17336: GEOMATE Journal Review and Evaluation:3rd reviewer

<u>Question</u>	<u>Answer</u>
Paper ID number	17336
Paper Title	Hydrochemical Assessment of Unconfined Aquifer System in Bayat Melange Complex, Klaten, Indonesia

HYDROCHEMICAL ASSESSMENT OF UNCONFINED AQUIFER SYSTEM IN BAYAT MELANGE COMPLEX, KLATEN, INDONESIA

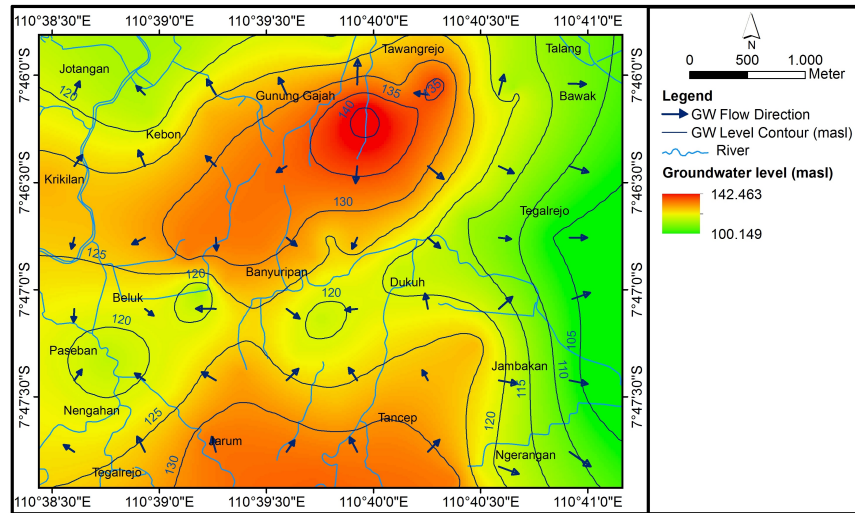
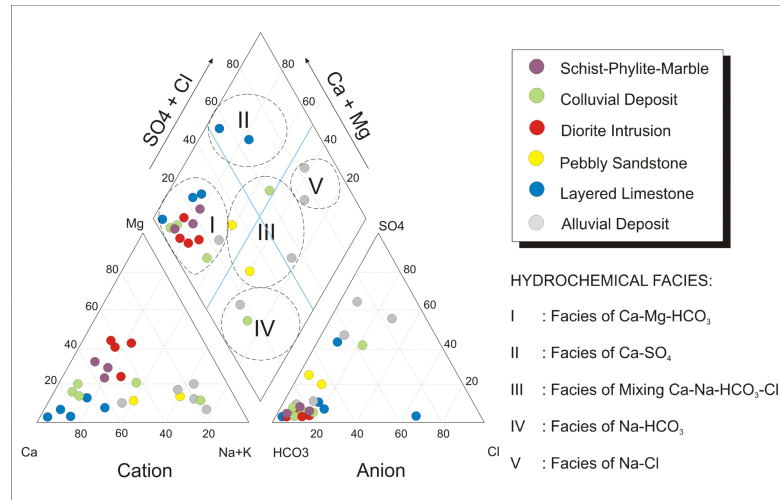
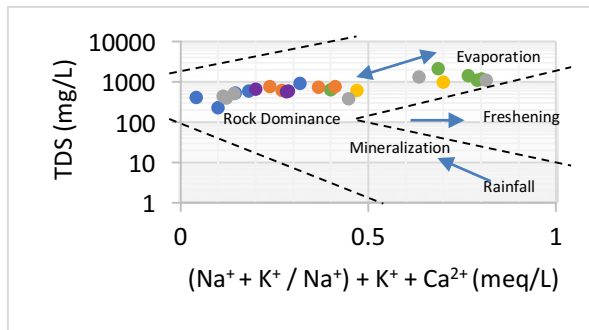
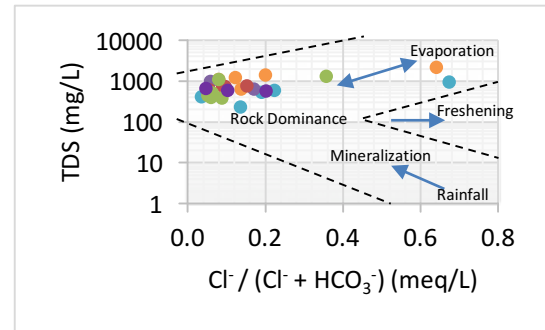
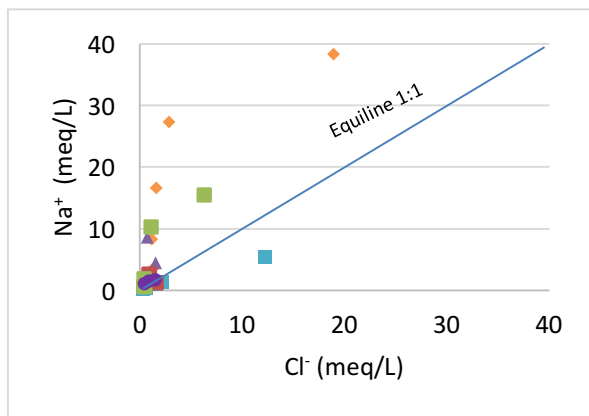
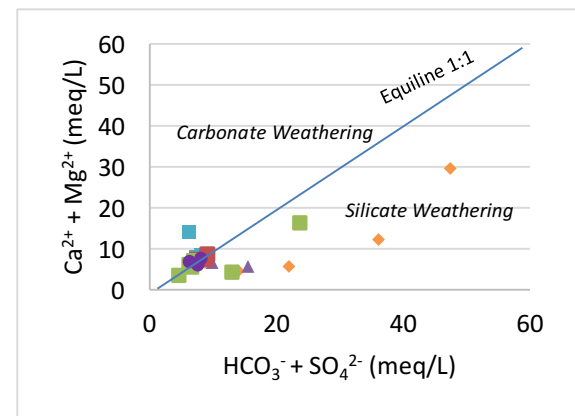
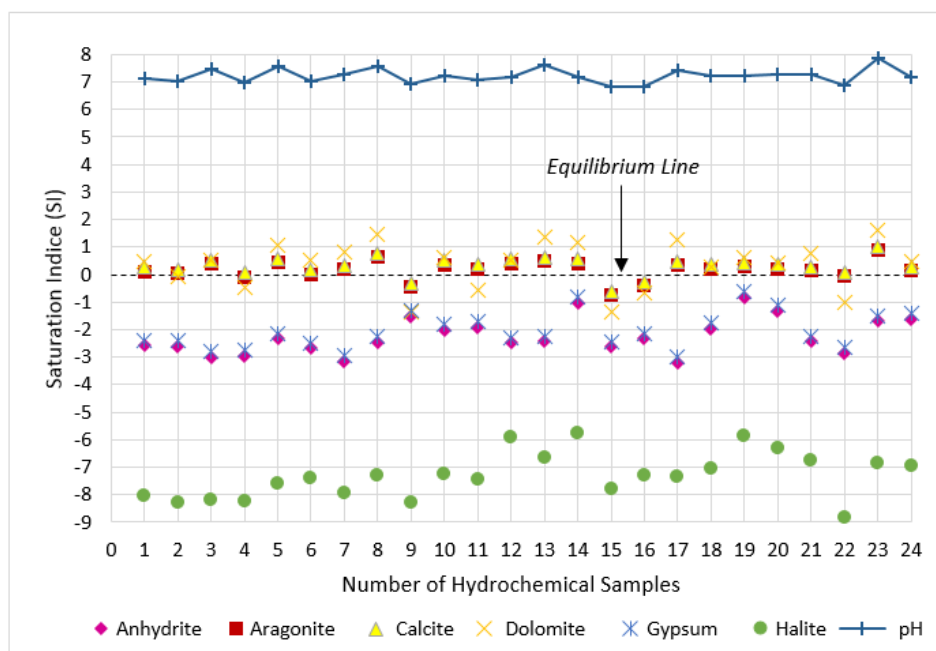
Texts inside Fig.2-10 are too small. If possible, make it larger.

Texts inside Fig.2-10 are too small. If possible, make it larger.
